# Route 33

**Subject:** FW: Proposed Route 33 revisions  
**Attachments:** Route33\_Revision.pdf

Please find attached planned revisions to Route 33 to address sub-optimal turning movements that were recently investigated.

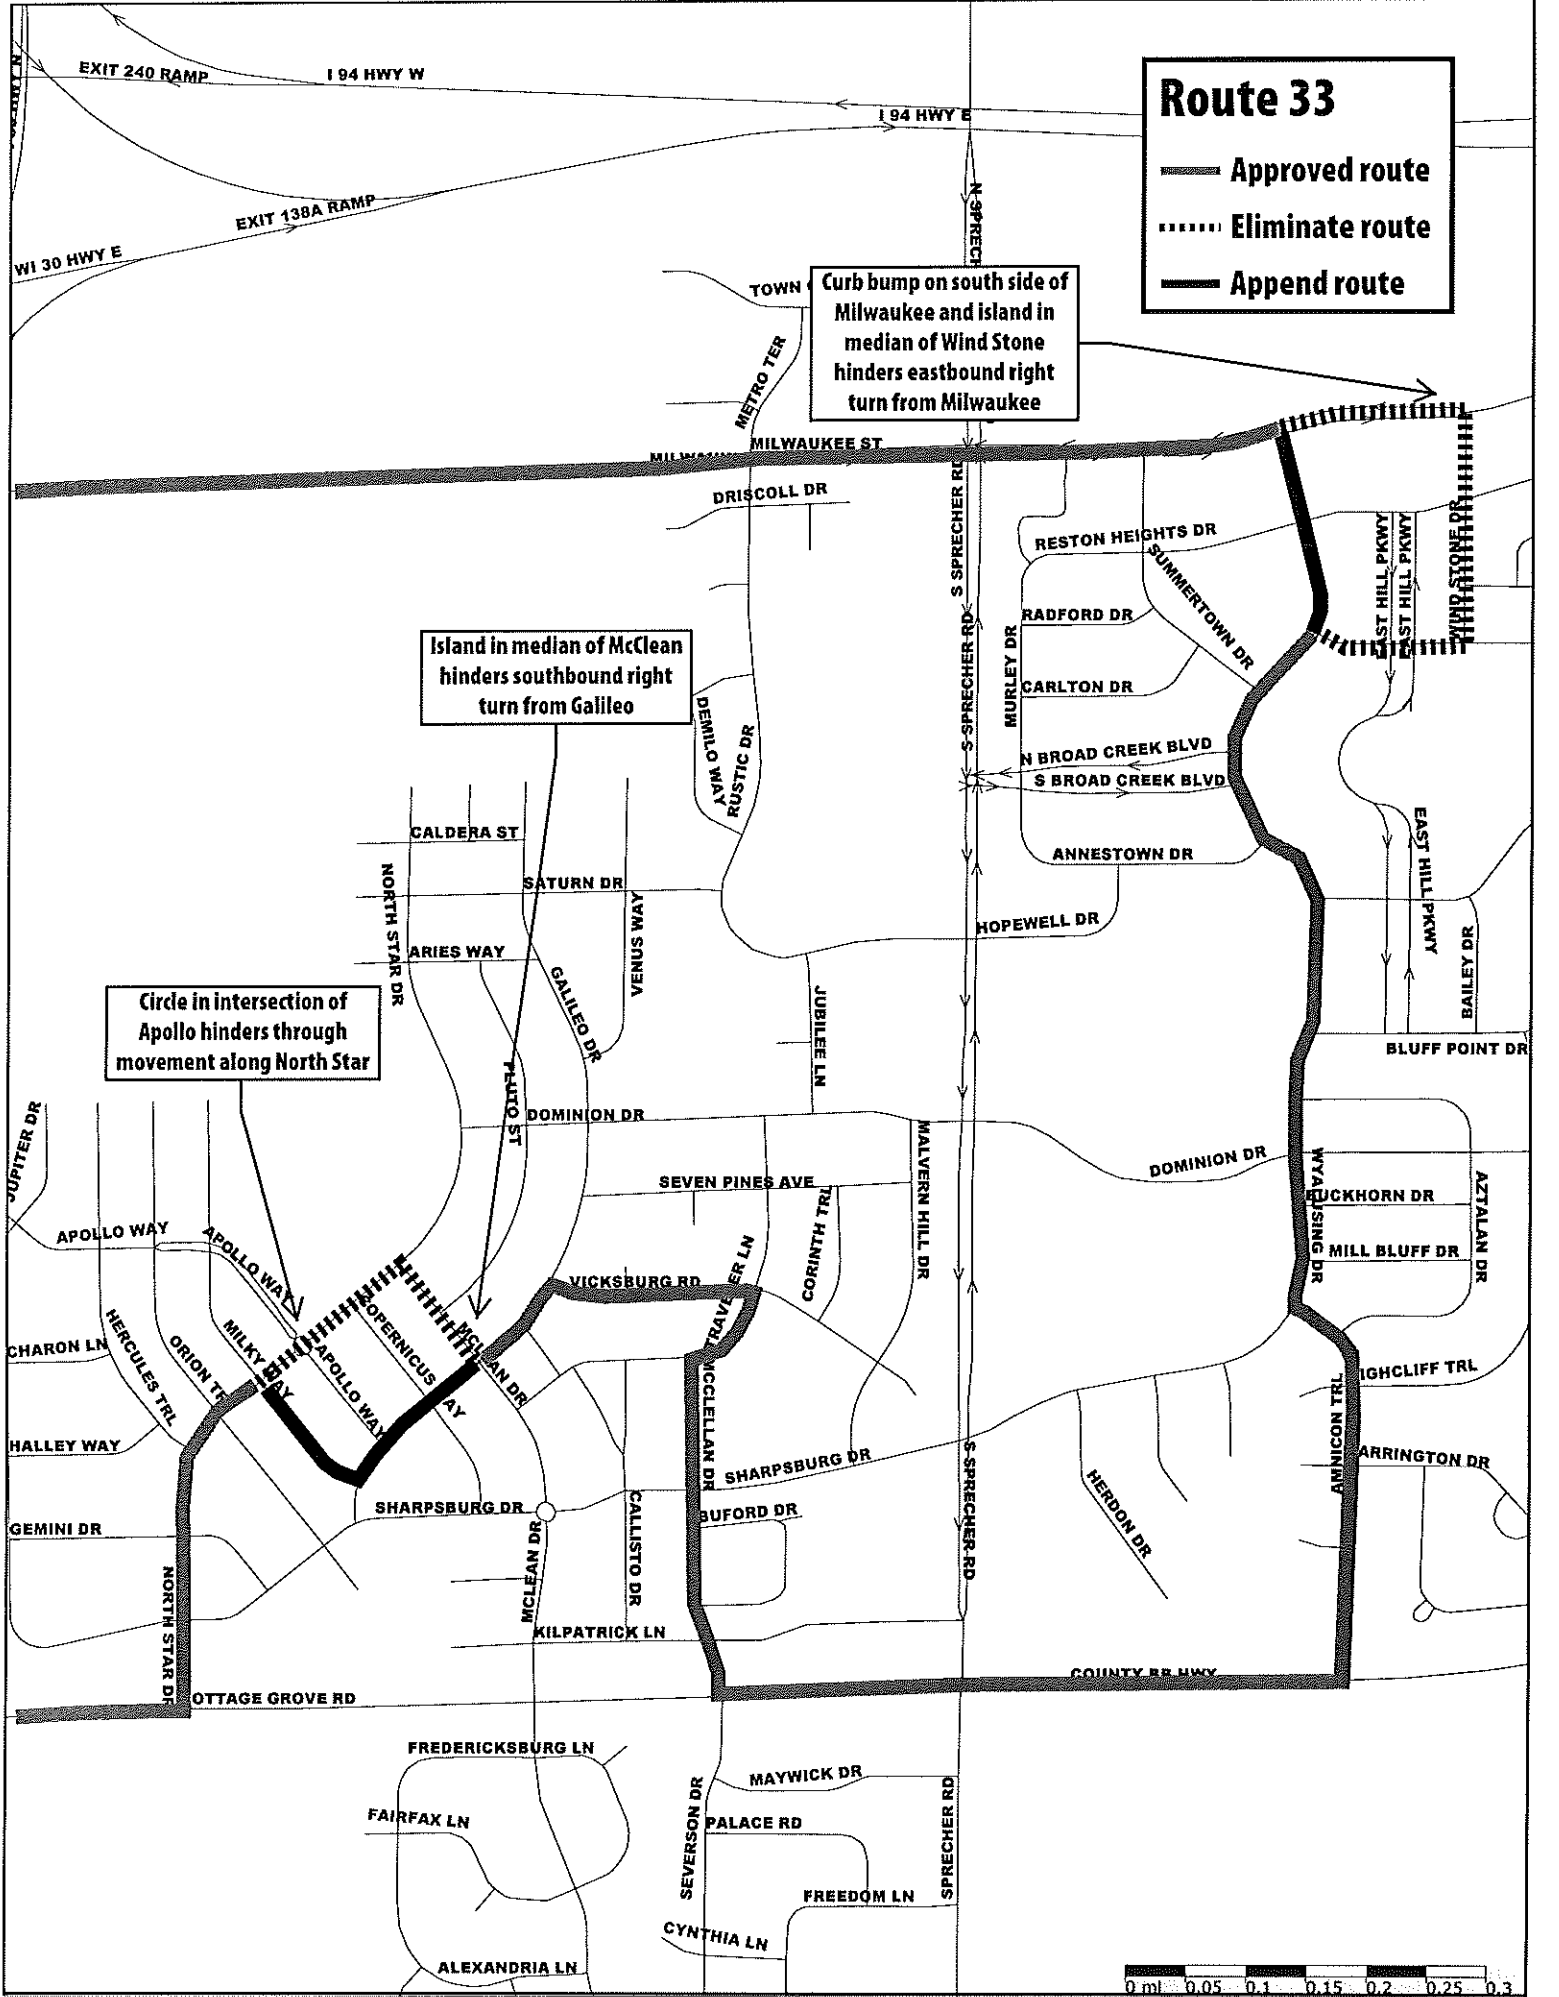
Curb bump on south side of Milwaukee and island in median of Wind Stone hinders eastbound right turn from Milwaukee

Island in median of McClean hinders southbound right turn from Galileo

Circle in intersection of Apollo hinders through movement along North Star

The planned Route 33 revision to using Wyalusing between Milwaukee and Littlemore will also impact supplemental school day trips. Those trips will also change to use Wyalusing between Milwaukee and Littlemore - in order to eliminate the right turn movement identified at Wind Stone.
